LUAS Cork

Public Consultation – Response

LUAS Cork – Preferred Route (PR)

Figure 1
the potential Greenfield lands which can be served by the proposed alignment

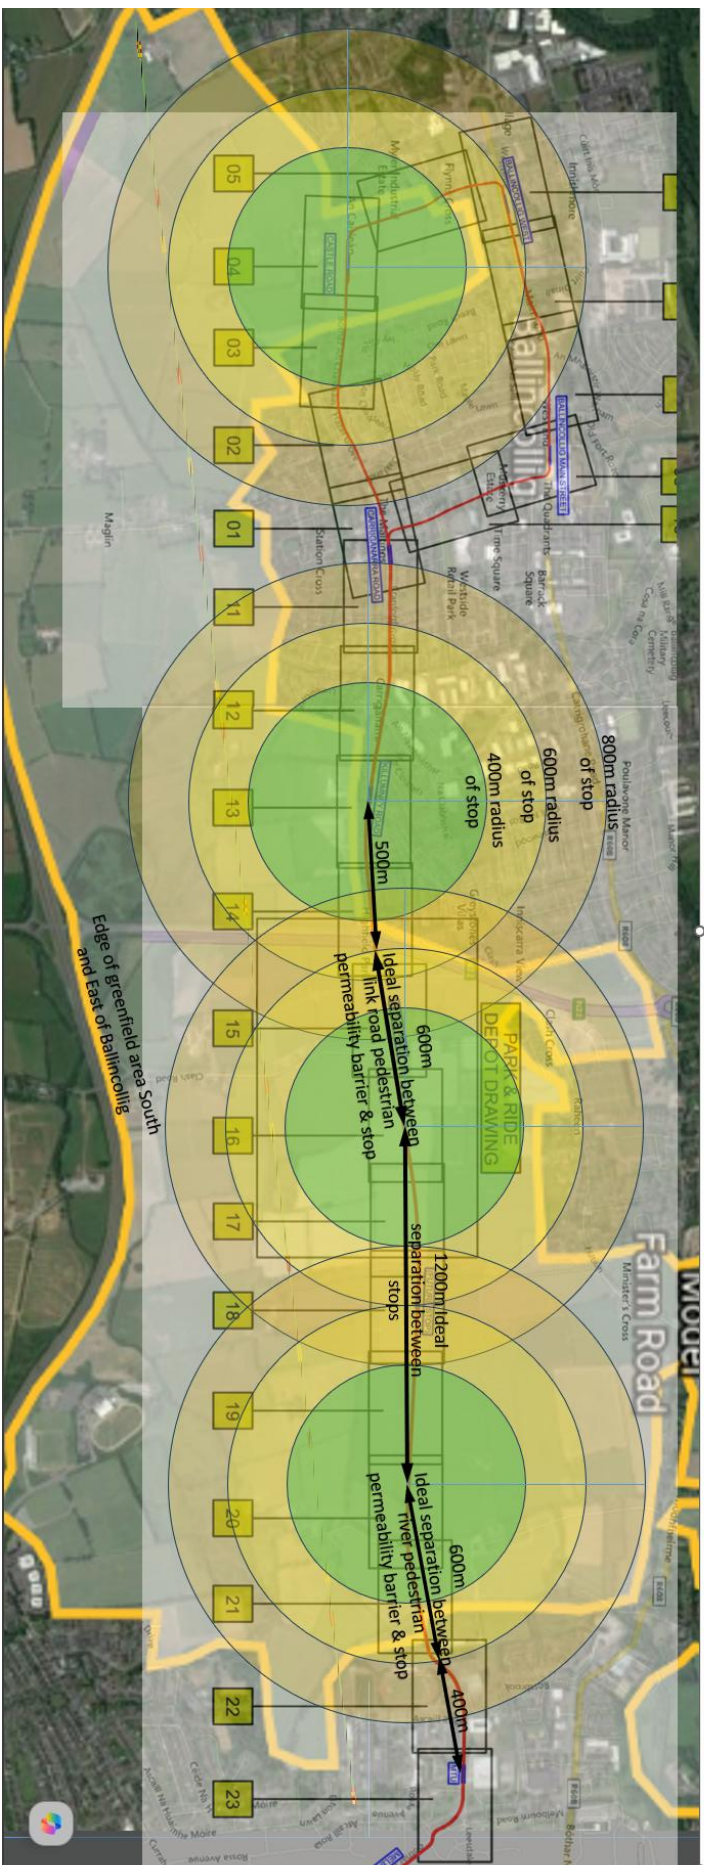
A key factor, determining the future level of use and the level of benefit of the LUAS system to the future development of the city, is maximizing development within a walking distance of stations. It is vital that these areas are developed at high density with good permeability to ensure the maximum number of residents, of workers, and of services are within walking distance of each station. Due to the existing low-density character and poor permeability of many existing areas of the city Most aspects of ensuring this is achieved are outside the scope of this consultation under more properly addressed as part of the city development plan.

However, the placement and orientation of stations and how they connect to the existing and future street network is a key importance in allowing the optimization of future urban development to allow this high-density permeable development to take place. Where stations are placed in areas which are already development developed, which is the case on most of the line, there is limited opportunity for further development and hence for the optimization of rail and stop alignment to facilitate this. As well as many preexisting constraints limiting optimization. However, were the line runs to or adjacent to a green field situation particularly in the section between MTU and Ballincollig this should be a key consideration at this stage. See Figure 1 showing potential for high density transit oriented green field development in proximity to the proposed alignment.

See Figure 1

Figure 2
Dunboyne as illustration of how the catchment area of a stop can be dramatical reduced by poor choice or stop location

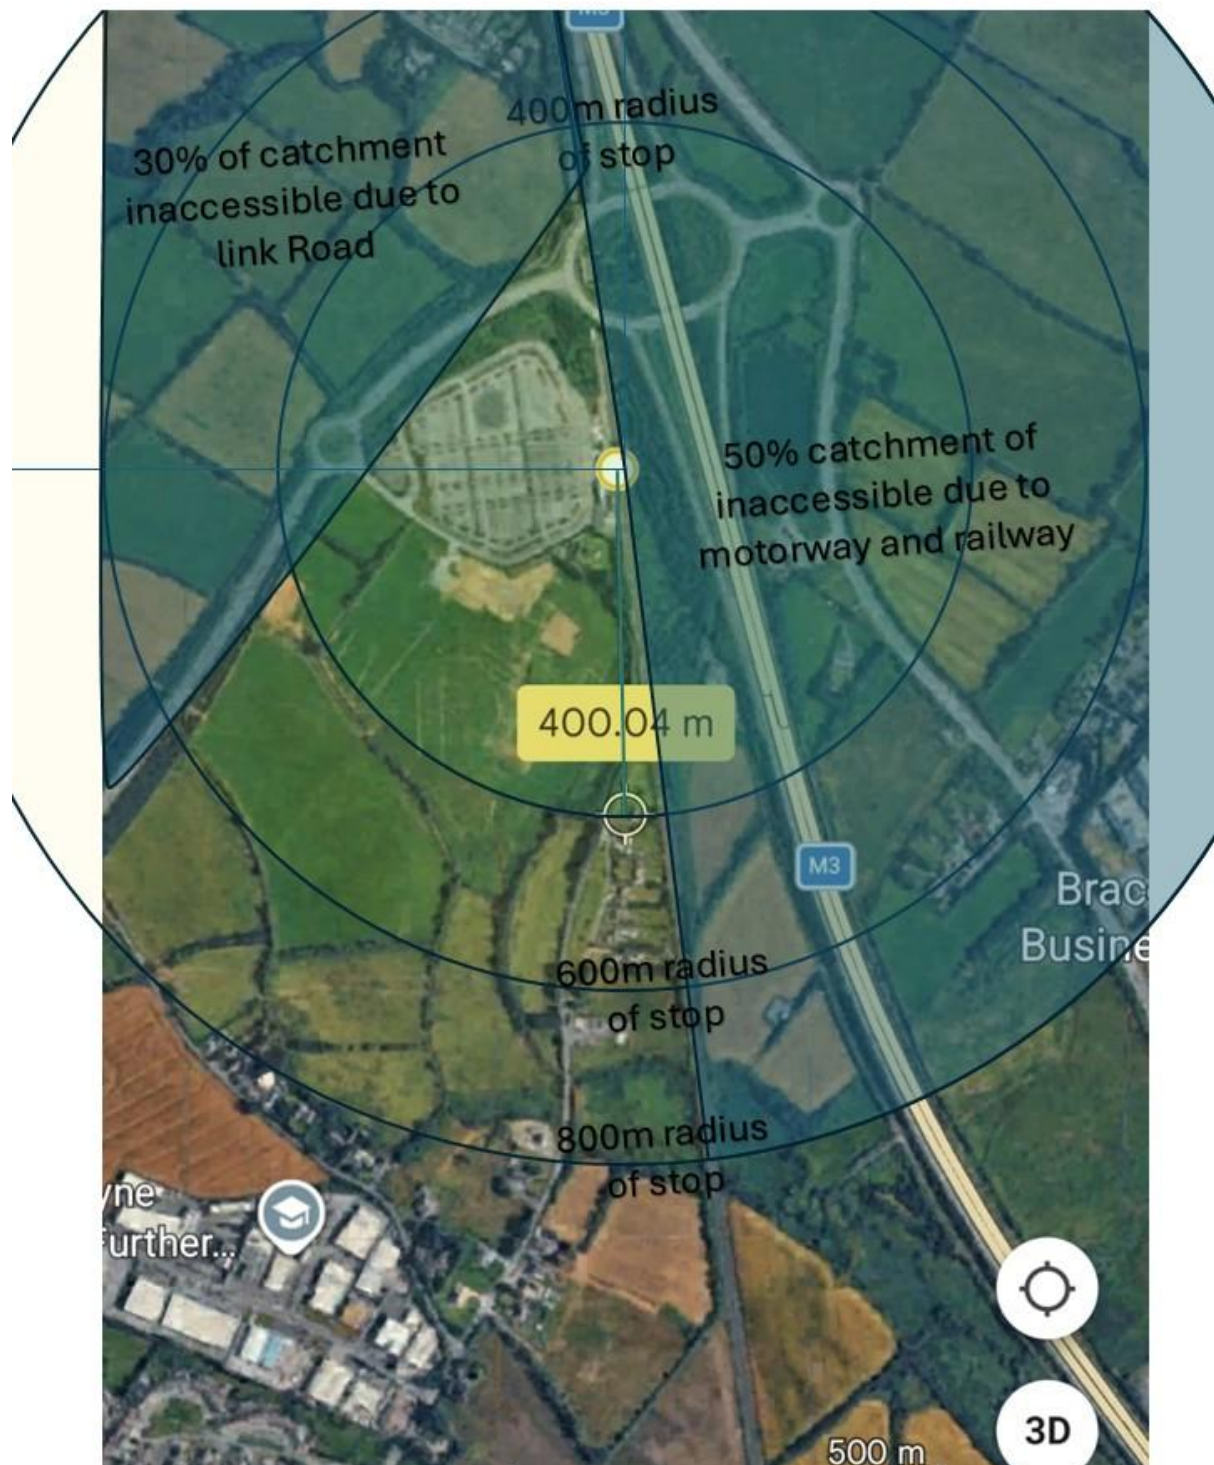
We are particularly concerned to avoid poor examples of the siting and access arrangement for newly constructed stations in Ireland which prevent the development of a residential or office space in close vicinity to the station hence severely limiting the population which can be served. For example, the M3 Parkway station outside Dunboyne County Meath is placed between the motorway and a limited access distributor road blocking pedestrian access from 3 sides and preventing any residential or commercial development to address the station.

See Figure 2

In general, anything that block direct pedestrian access and low intensity usages such as parking, distributor roads, warehousing distribution etc. within should be avoided within 800 m of a station. However, we acknowledge that there are some low intensity uses such as depots, sidings, and Park and ride which must be located adjacent to the tracks and in close proximity to the stations. In order to minimise the impact of future high-density transit-oriented development care should be taken when planning the track alignment and station layout to ensure that these can be facilitated without blocking all access to the station and minimizing the amount of land in close vicinity to the stations which are used for such activities. In an idealized situation of unimpeded pedestrian routes radiating out from a “Green Field” station with very high-density transit-oriented development 0-200m walking distance from the station, high-density transit-oriented development 200-400m, medium high density 400-600m, and medium density 600-800 up 80,000 residents can be housed with 15 minutes’ walk of each station. While theoretically optimised maximums are never achieved in practice, a population 20,000 around each stop between MTU and Ballincollig is achievable

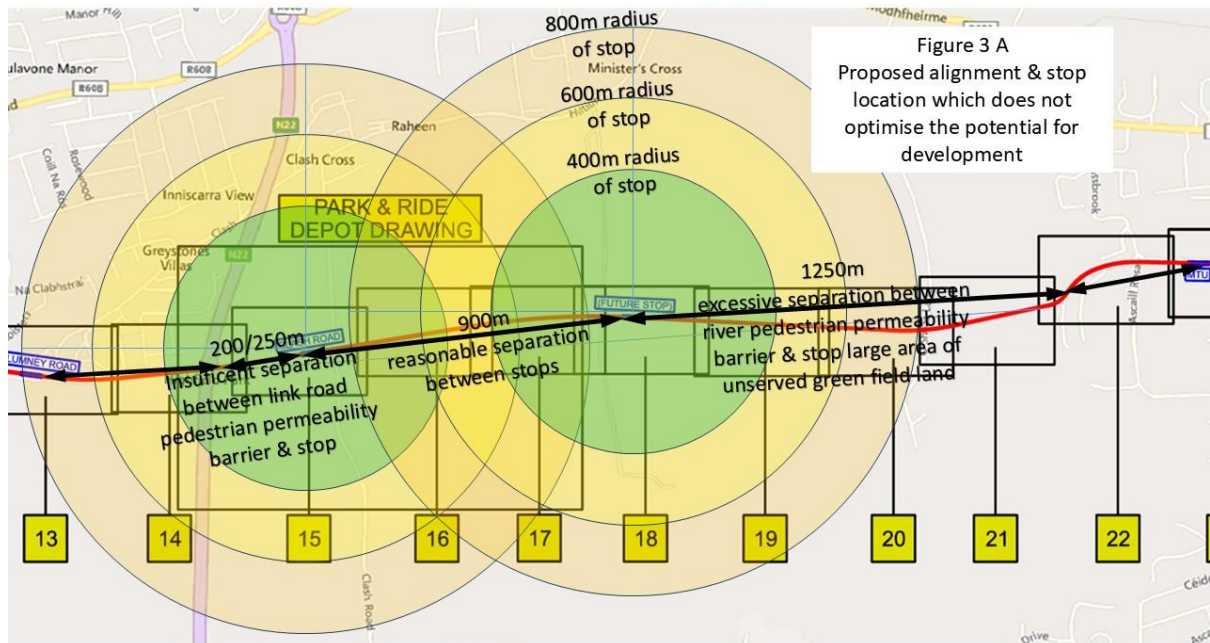
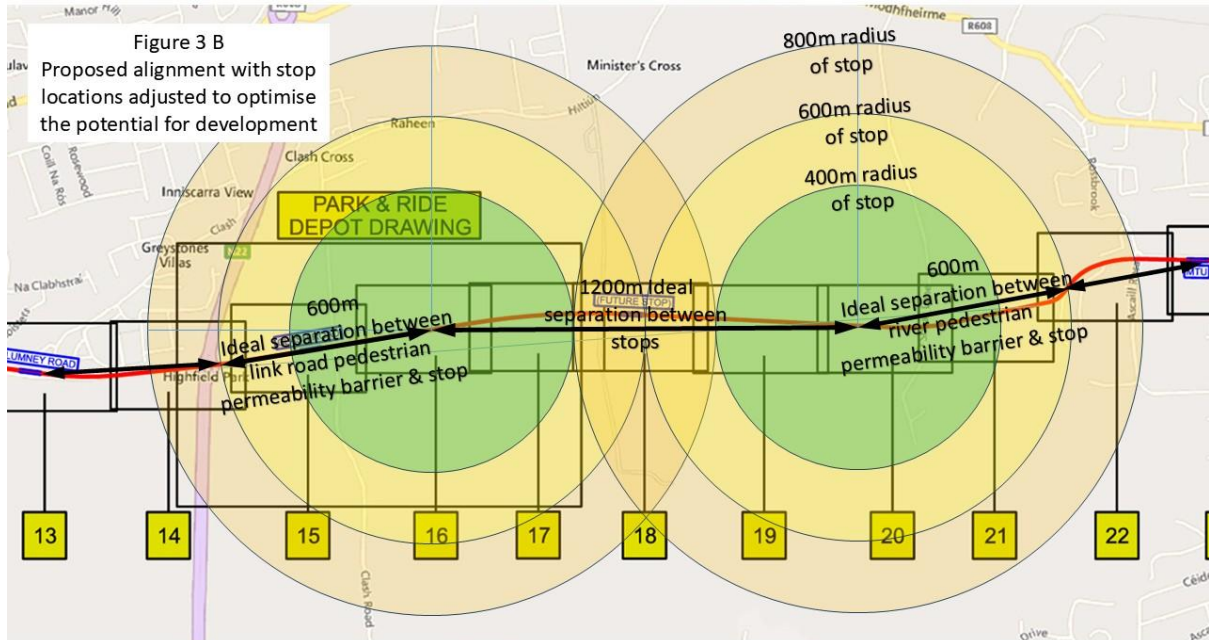
Locating stations at least 500-600m meters from distributor roads, or other features which block pedestrian permeability.

Situating sidings, depots, and maintenance infrastructure equidistant between stops as far from both as possible.

Sidings, depots, and maintenance infrastructure as well as park and ride are all on the same quadrant of the stop’s vicinity.

Ensuring road access to sidings, depots, and maintenance infrastructure as well as park and ride is oriented away from the stop

See Figure 3
